EXTERIOR & ADA RENOVATIONS
FOR THE
GLOUCESTER TOWNSHIP BLACK BOX
COMMUNITY CENTER
3 S. BLACK HORSE PIKE
BLACKWOOD, NEW JERSEY 08012

TOWNSHIP REVIEW COMMENTS			
No.	DATE	DESCRIPTION	REV'D BY
REVISIONS			
APPROVAL:		PROJECT:	
Joseph F. McKernan Jr., R.A. 100 Dobbs Lane Suite 204 Cherry Hill, New Jersey 08034		ADA RENOVATIONS TO THE GLOUCESTER TOWNSHIP BLACK BOX COMMUNITY CENTER 3 S. BLACK HORSE PIKE BLACKWOOD, NEW JERSEY	
TITLE: LIFE SAFETY PLAN & DETAILS		DRAWING NO: LS-1	
SEAL:		SCALE: AS NOTED	
JOSEPH F. MCKERNAN JR., R.A. A.I.A. NJ ARCH. NO. 0004 PA ARCH. NO. 0004-01 CT ARCH. NO. 0004		PROJ. NO.: 106 DATE: 9/14/23 REV'D: DRAWN BY: TC CHKD BY: DF

1 DEMO ROOF PLAN- EXTERIOR WORK
DA-4 SCALE: 1/4" = 1'-0"

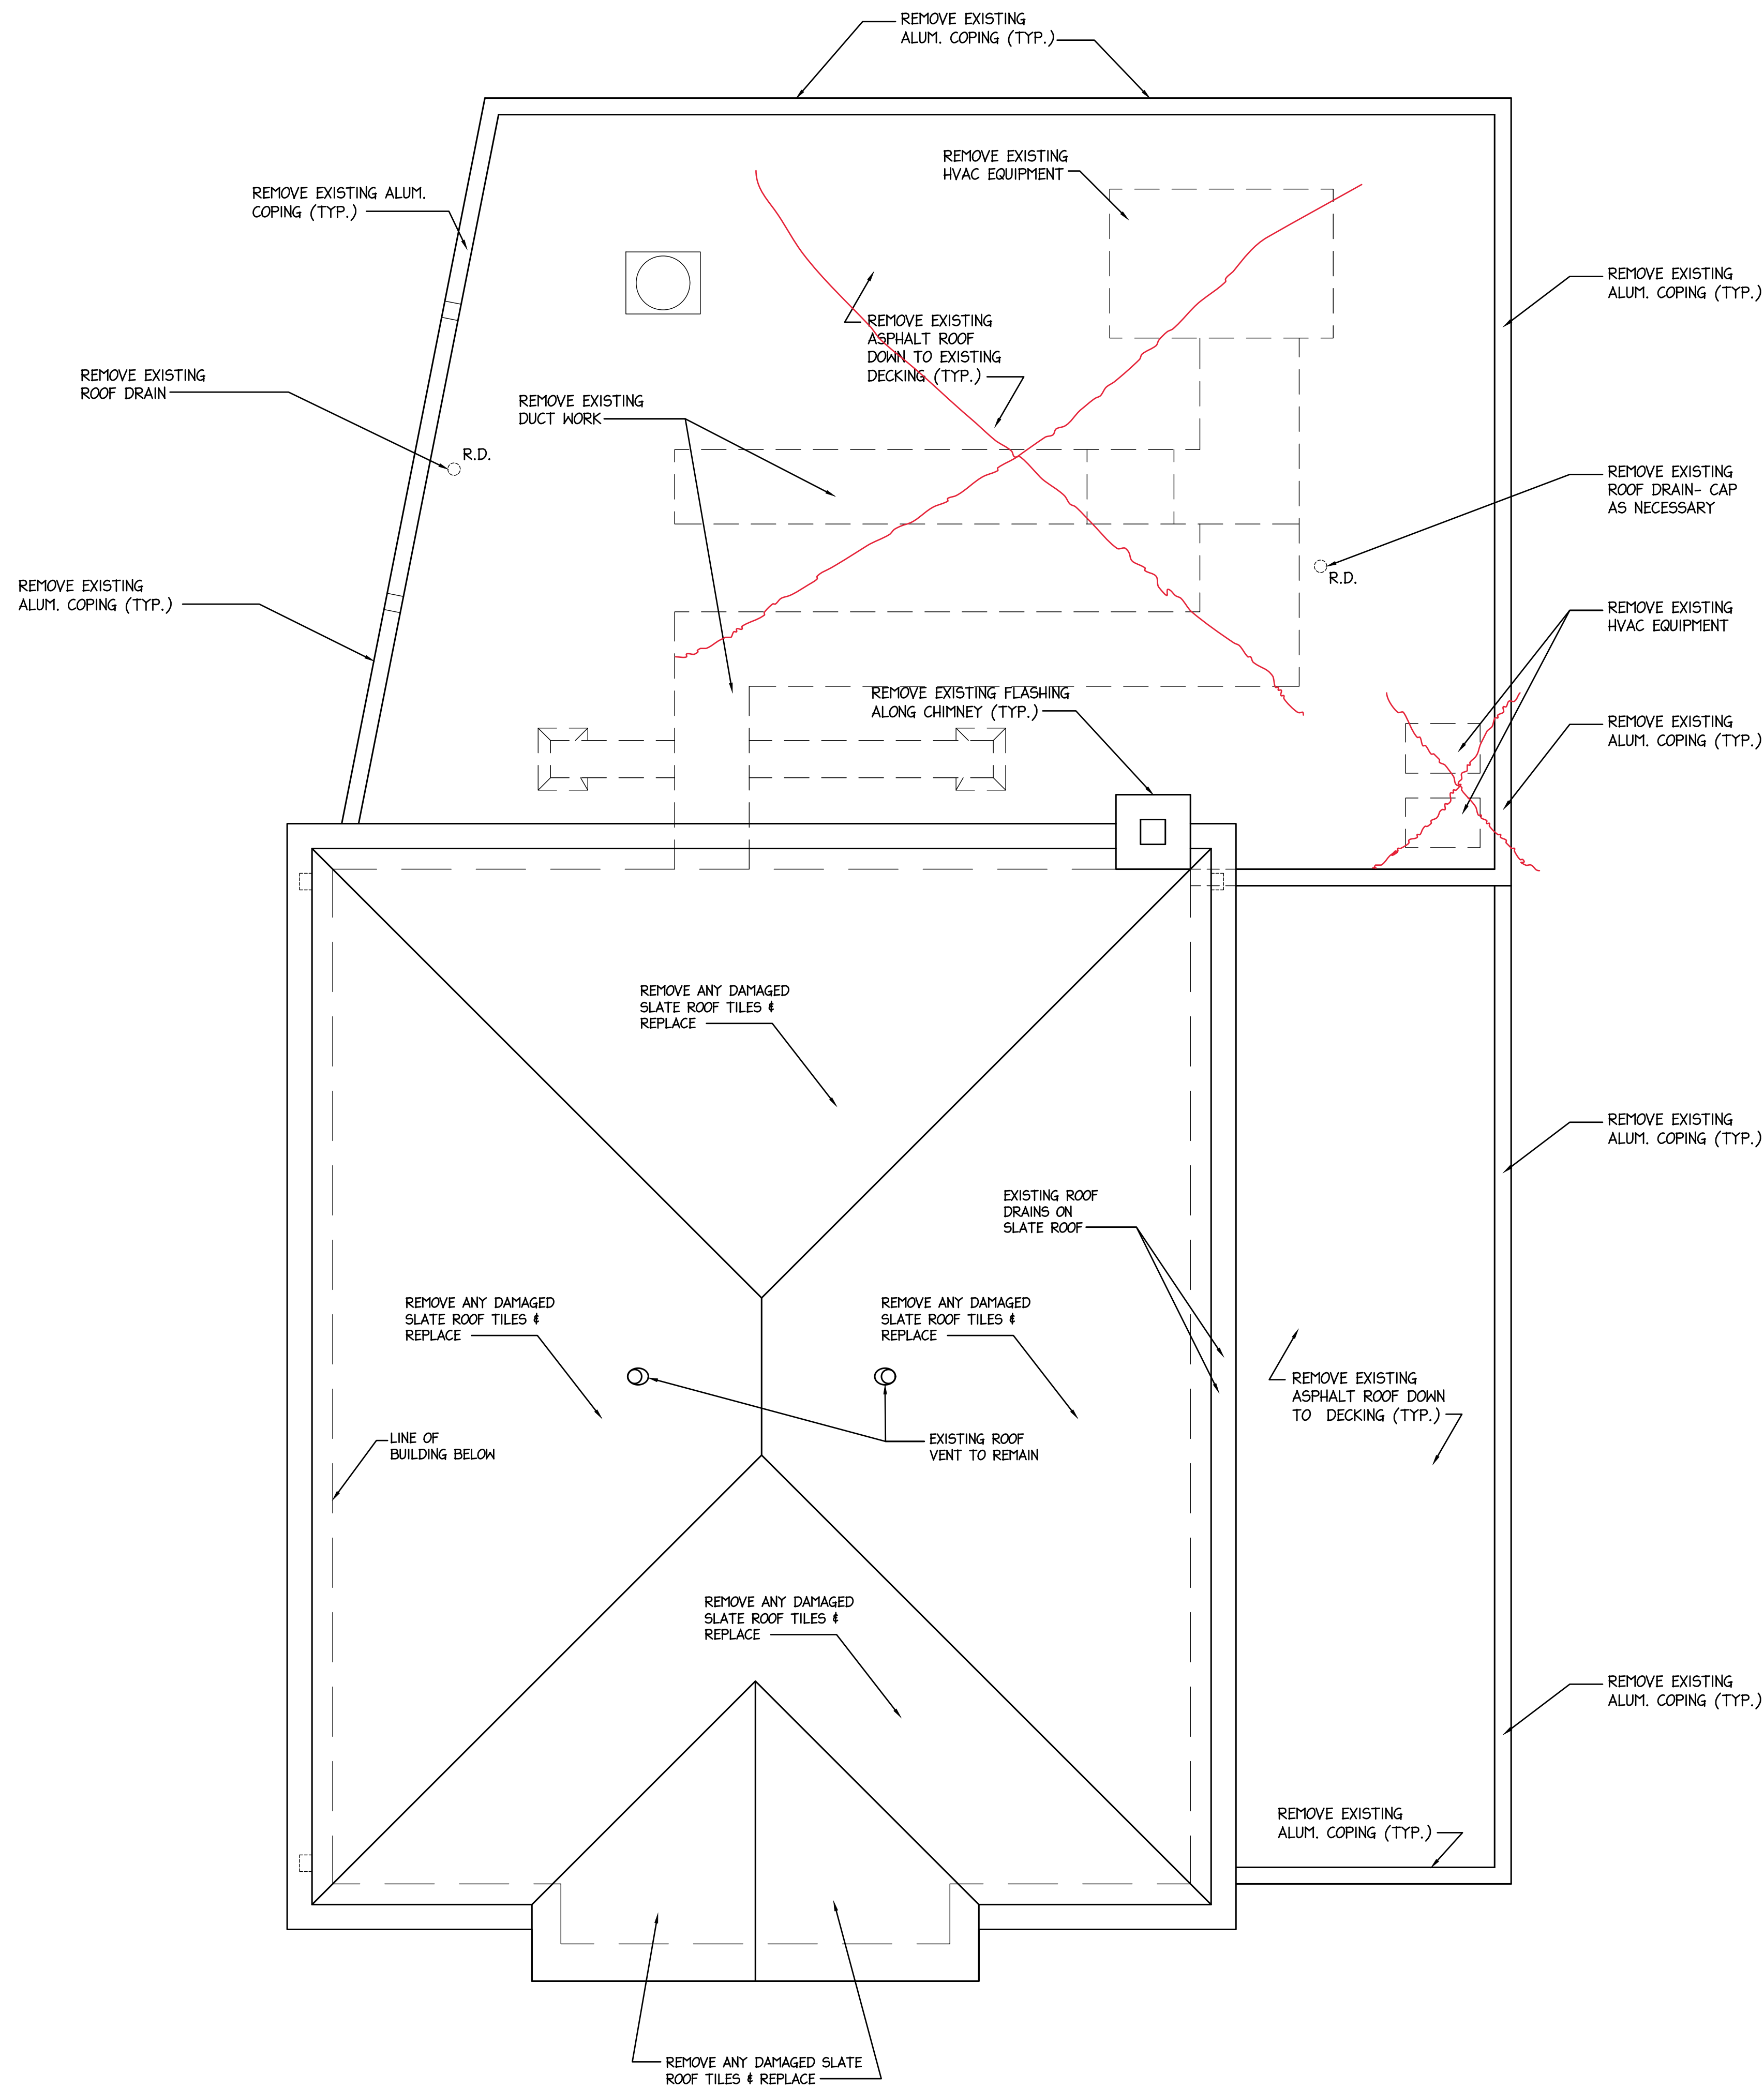
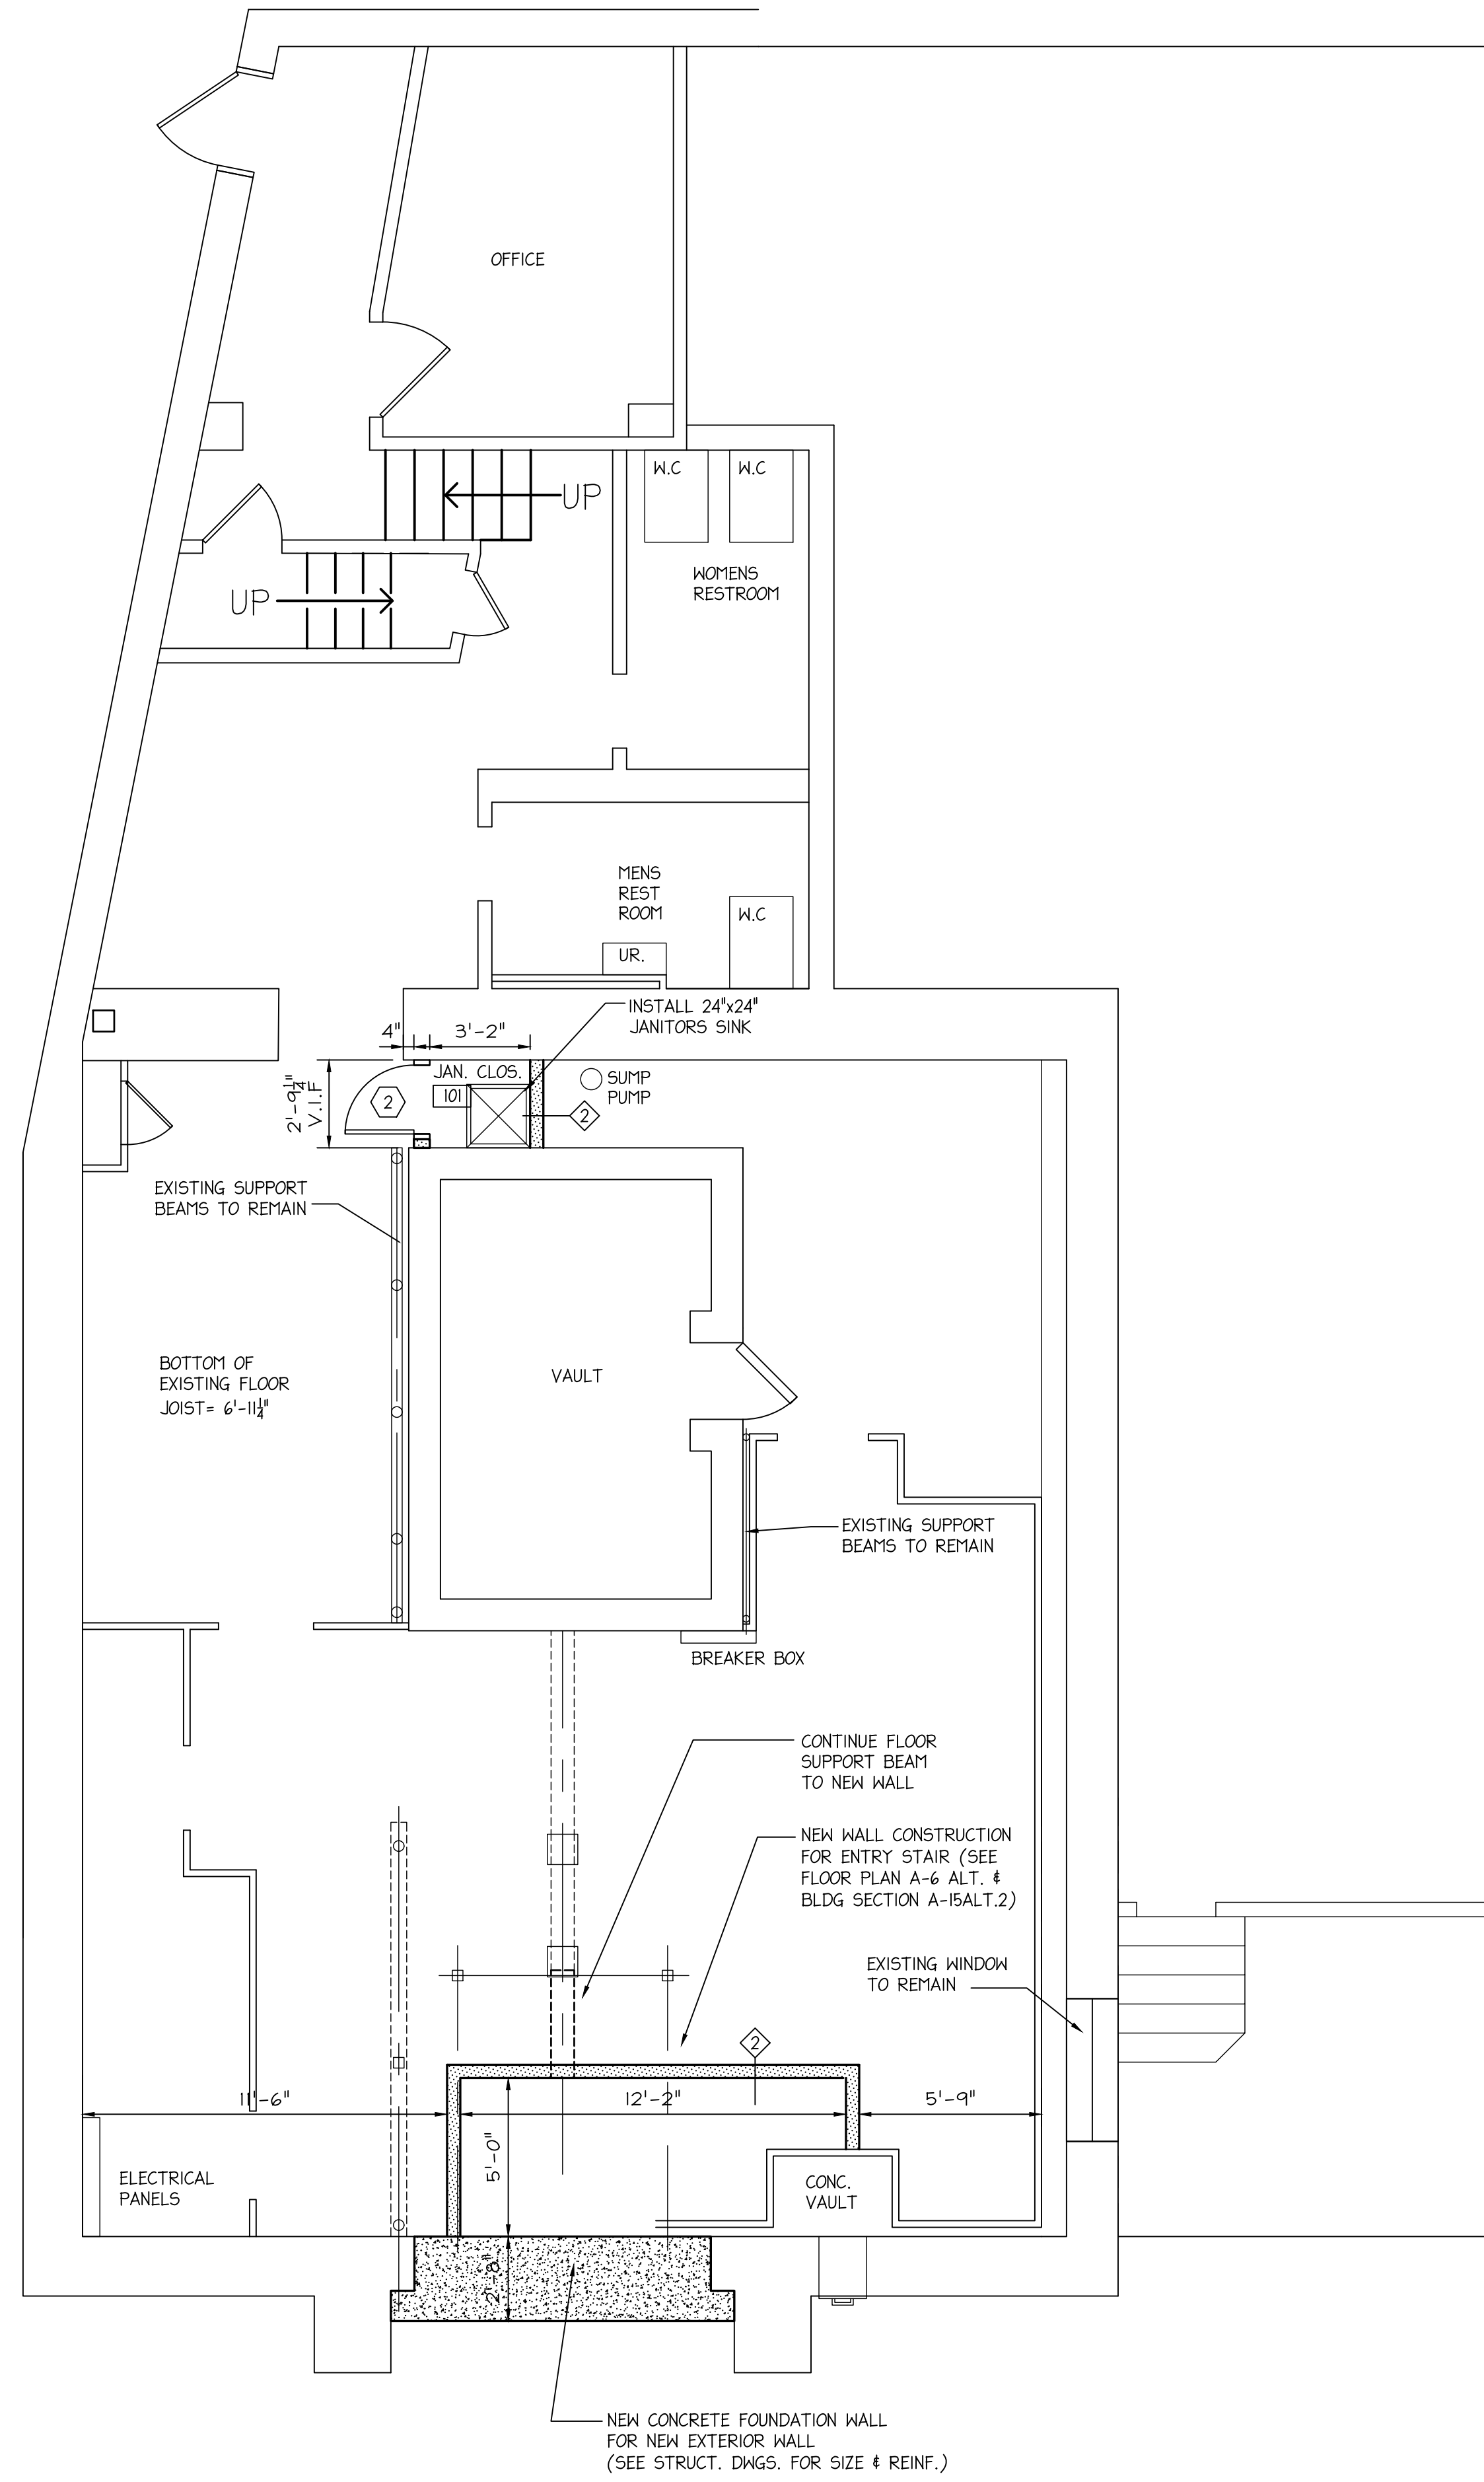
The Owners had a Phase 1 Cleanup already;
They removed all the ductwork and units;

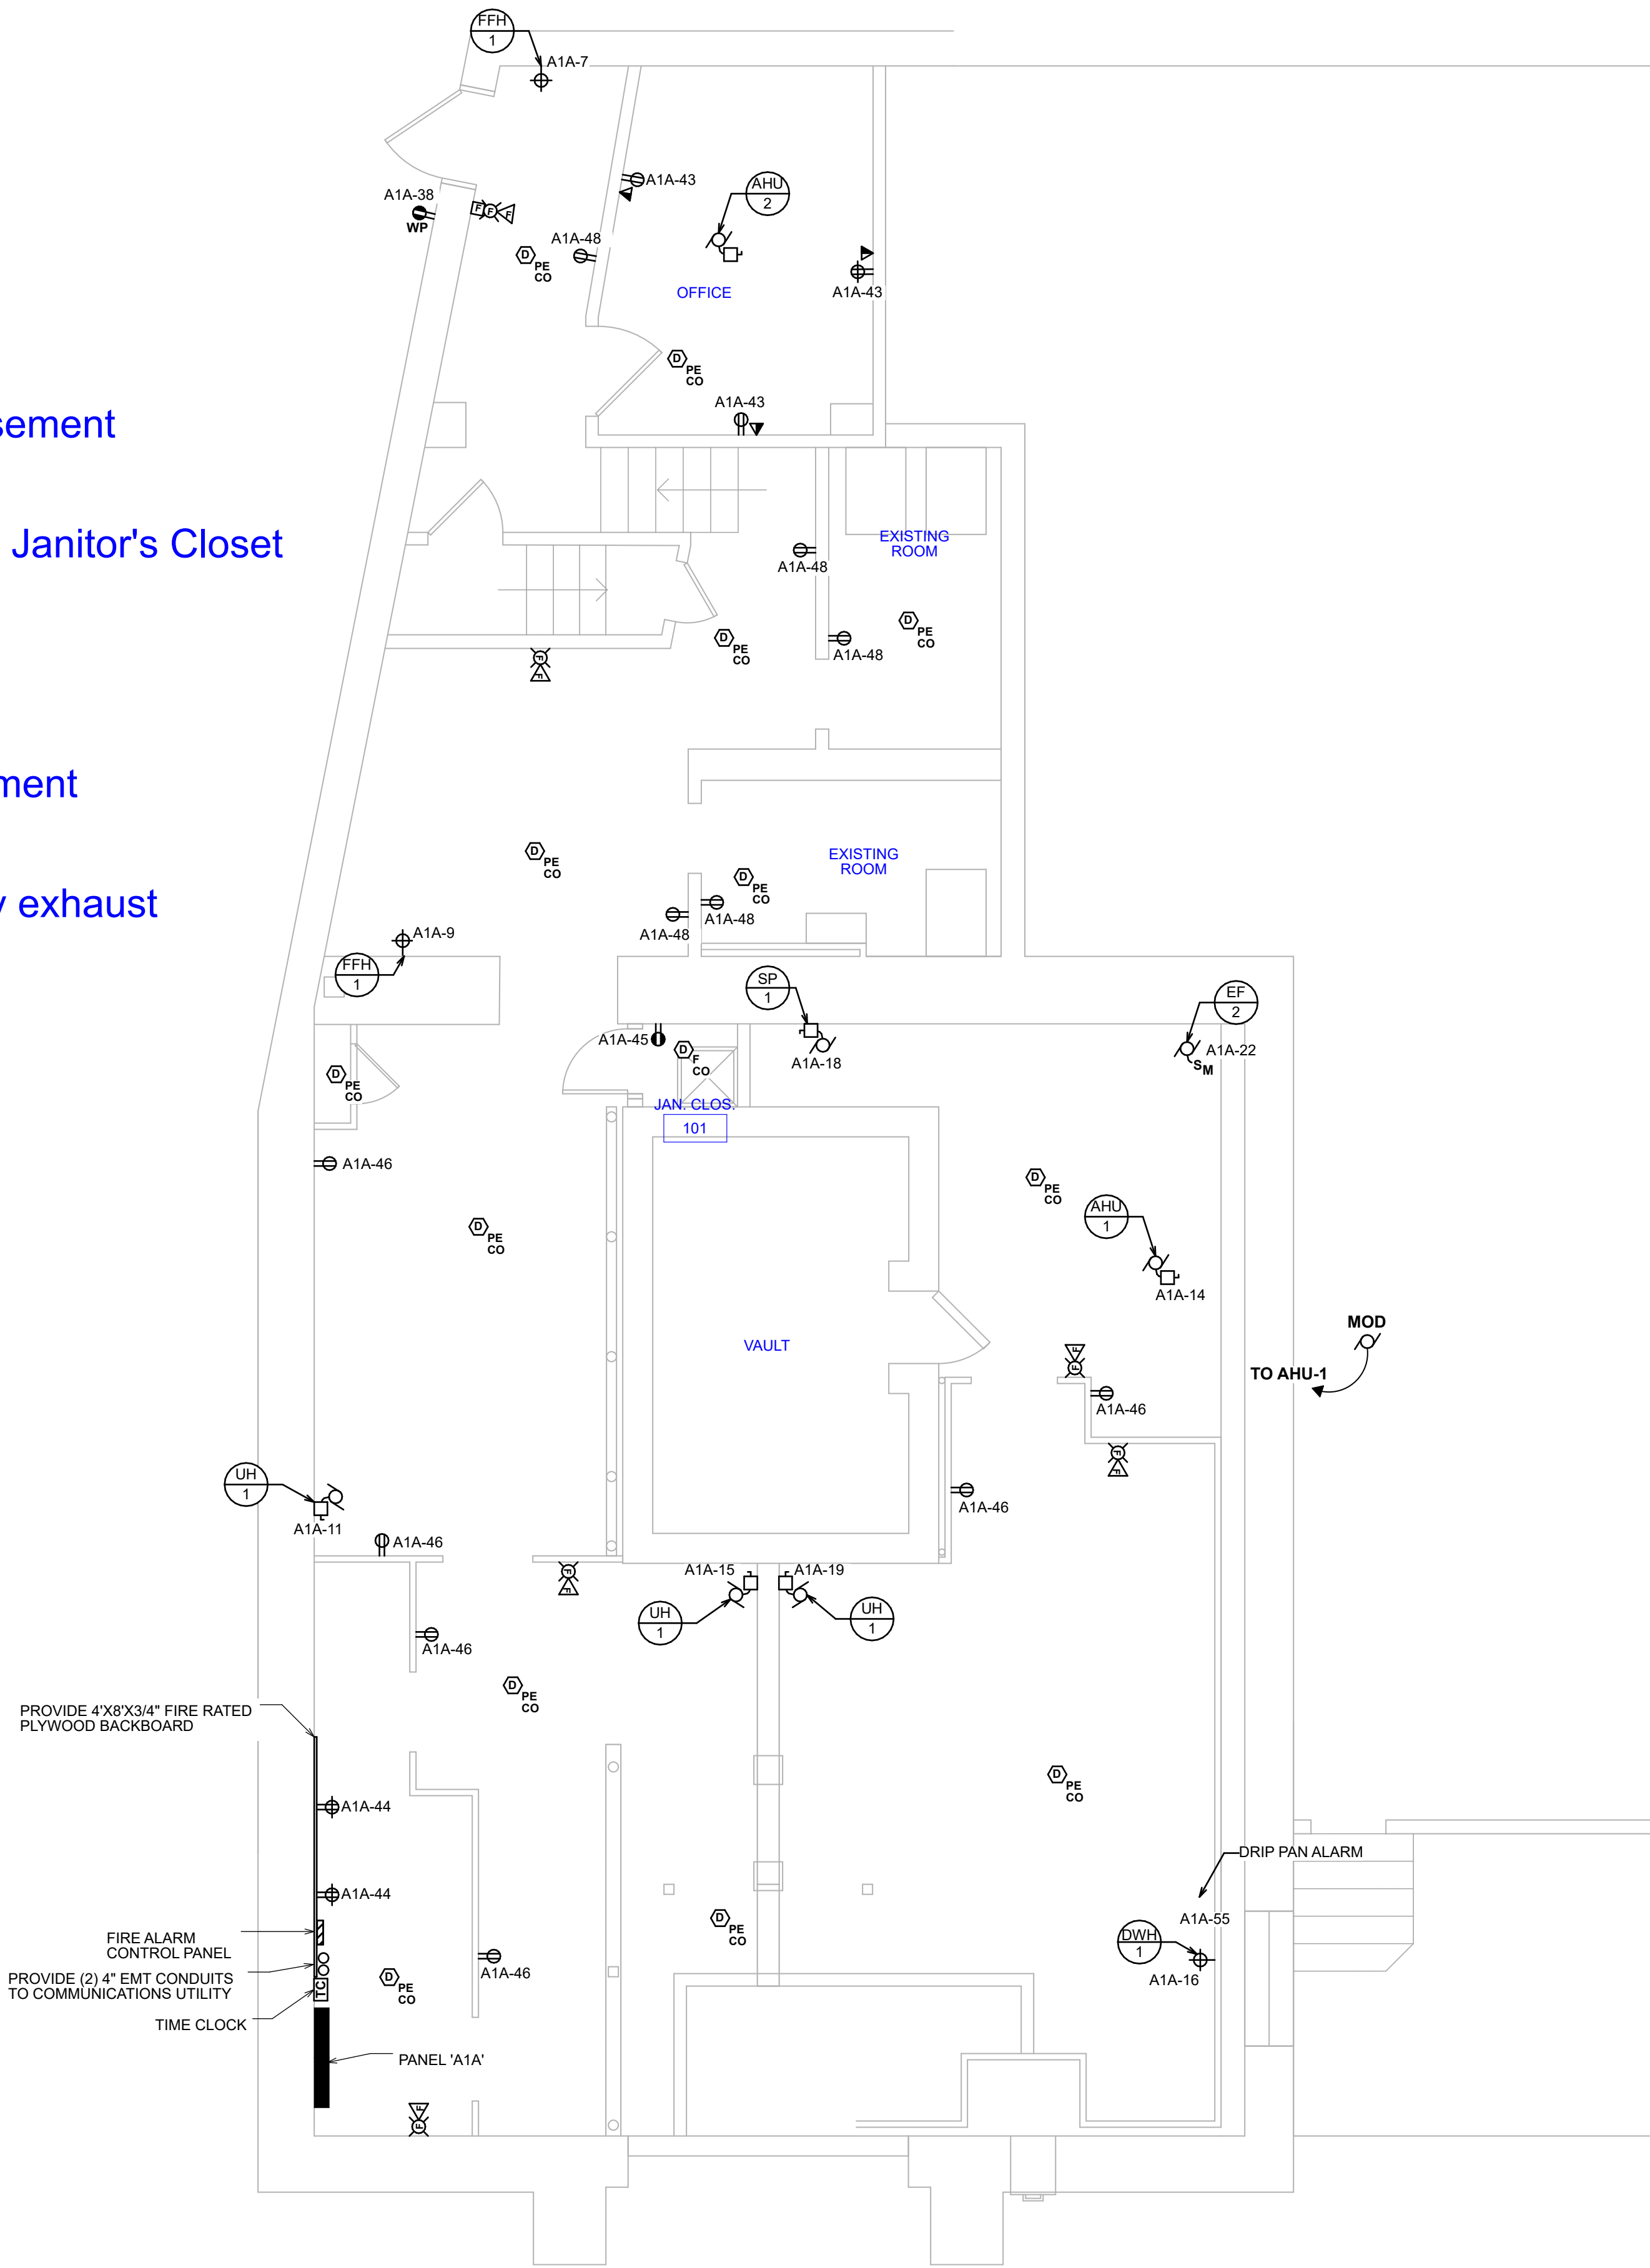
We need a light, switch and outlet in the Janitor's Closet

Power to the sump pump

We need temporary lighting in the basement
